Gunyama Stage 2 Pre-Construction Detailed Design Road Safety Audit

Pre-Construction Detailed Design Road Safety Audit

Client: Place Design Group

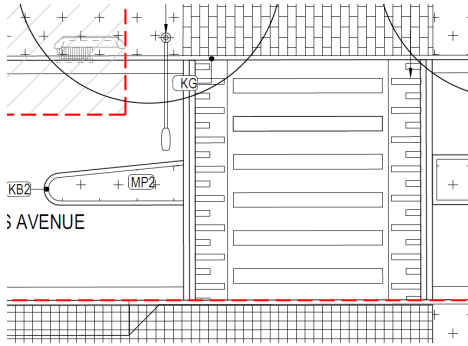
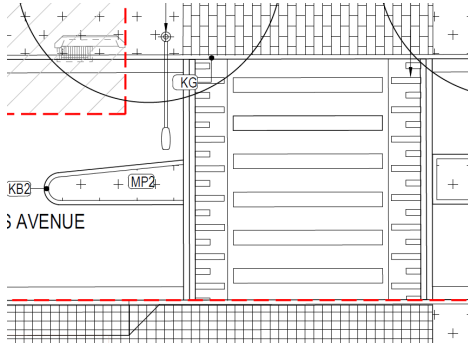
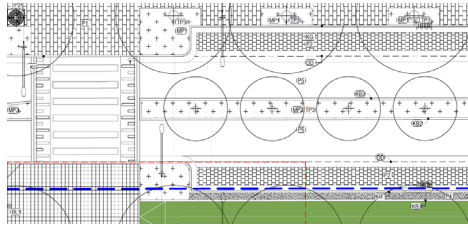
Item No.	Location	Descriptions of Findings	Design/ Photo	Likelihood	Severity	Risk Rating	Designer Response
1.	George Julius Avenue, north of Peters Street	<p>It is ambiguous to provide a median island on approach to the pedestrian crossing as motorists may confuse it with a pedestrian refuge where vehicles have priority over pedestrians. However, pedestrians have higher priority on pedestrian crossings.</p> <p>The confusion may lead to conflicts between vehicles and pedestrians as a result.</p>		Rare	Moderate	Low

2.	Pedestrian crossing facility in George Jullius Avenue	<p>The future path connecting George Jullius Avenue and Gunyama Park will generate some cyclist demand. However, the proposed pedestrian crossing in George Julius Avenue does not cater for cyclist movements to/from the cycleway and Gunyama Park located on the other side of the road.</p> <p>Mixing cyclists and pedestrians in the crossing facility creates conflicts due to the different speeds, and may lead to injury in case of collisions.</p>		Unlikely	Minor	Low

3.	Pedestrian crossing facility in George Jullius Avenue	<p>Sight distance to the pedestrian crossing may be obstructed by trees located in the median. As a result, motorists may not see pedestrians and cyclists about to use the crossing and thus increasing the likelihood of collisions.</p>		Rare	Moderate	Low

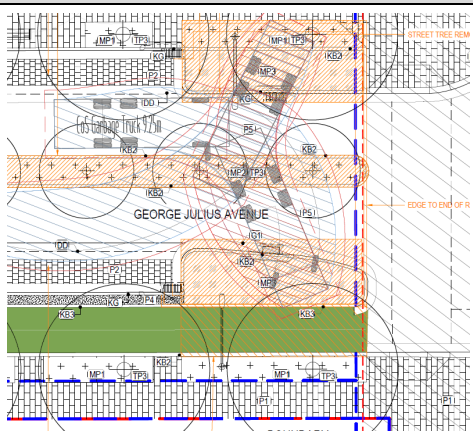
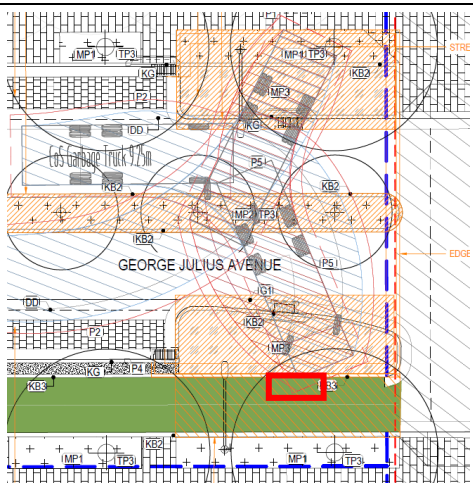
Item No.	Location	Descriptions of Findings	Design/ Photo	Likelihood	Severity	Risk Rating	Designer Response
4.	Temporary turning area at the northern end of George Julius Avenue	It is not clear if a kerb would be provided to separate the turning area from the footpath and the cycleway.		-	-	Note only

5.	Temporary turning area at the northern end of George Julius Avenue	<p>The temporary turning area is not sufficient to fully accommodate the swept path of a council waste collection vehicle making a three-point turn. Clearance of the vehicle encroach onto the footpath and cycleway on each side of the road.</p> <p>Cyclists may perceive the truck is getting too close to the cycleway. This may result in evasive action and swerving suddenly to the opposite side of the path. This may result in conflict with another cyclist in the cycleway which may lead to minor injury.</p>		Rare	Moderate	Low

Figure 1. Example of a continuous footpath treatment layout.

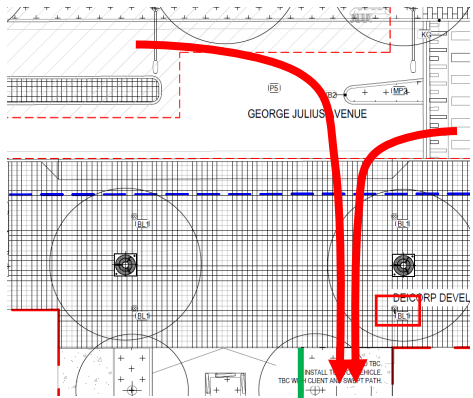
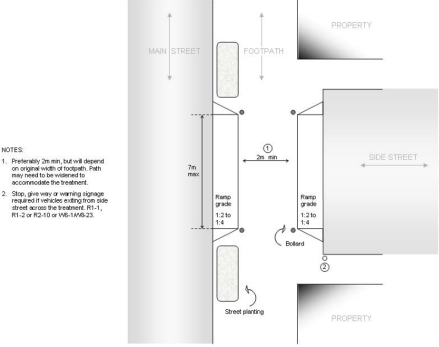
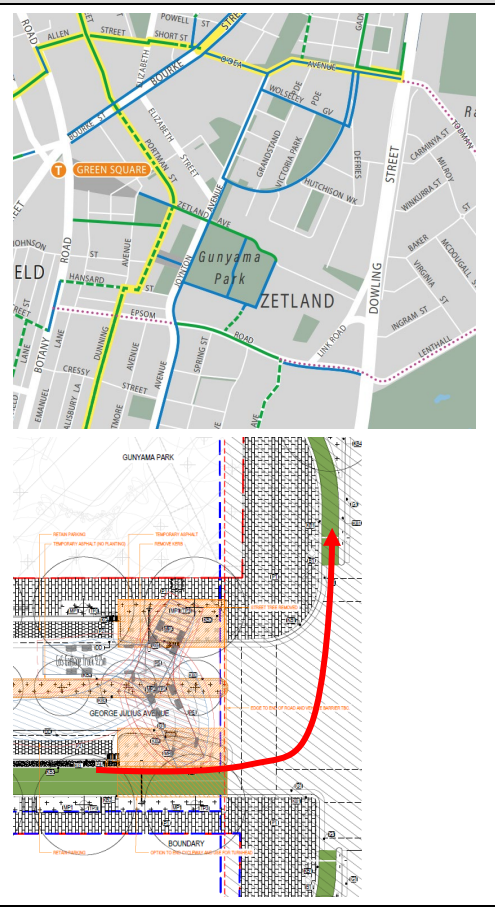
Item No.	Location	Descriptions of Findings	Design/ Photo	Likelihood	Severity	Risk Rating	Designer Response
6.	Intersection of George Julius Avenue and Peters Street	<p>The bollard located at the north-eastern corner of the continuous footpath treatment is considered incorrect.</p> <p>If motorists use the bollards as a means of delineation when turning from George Julius Avenue onto Peters Street during low lighting conditions, they may end up in the footpath in Peters Street. The green line shows the kerb line along Peters Street.</p> <p>This deficiency may mislead motorists to over-turn at the intersection. This may result in reverse movements to correct the wrong turn path towards Peters Street.</p> <p>Based on TfNSW Technical Direction TD13/05, bollards are installed close to the kerblines of the side road to define the area for vehicle turning movements. It is understood that the first bollard located closer to George Julius Avenue is to facilitate the swept path of a left turn vehicle onto Peters Street. Consideration should be given to relocating the second bollard (encircled) to the prolongation of the Peters Street kerblines.</p>	 <p>TfNSW Technical Direction TD13/05:</p>  <p>NOTES: 1. Generally 2m min, but will depend on original width of footpath. Path also needs to be widened to accommodate the treatment. 2. Stop, give-way or warning signage required if vehicles entering from side street access the treatment. R1-1, R1-2 or R2-10 or VMS-14WB-23.</p>	Unlikely	Minor	Low
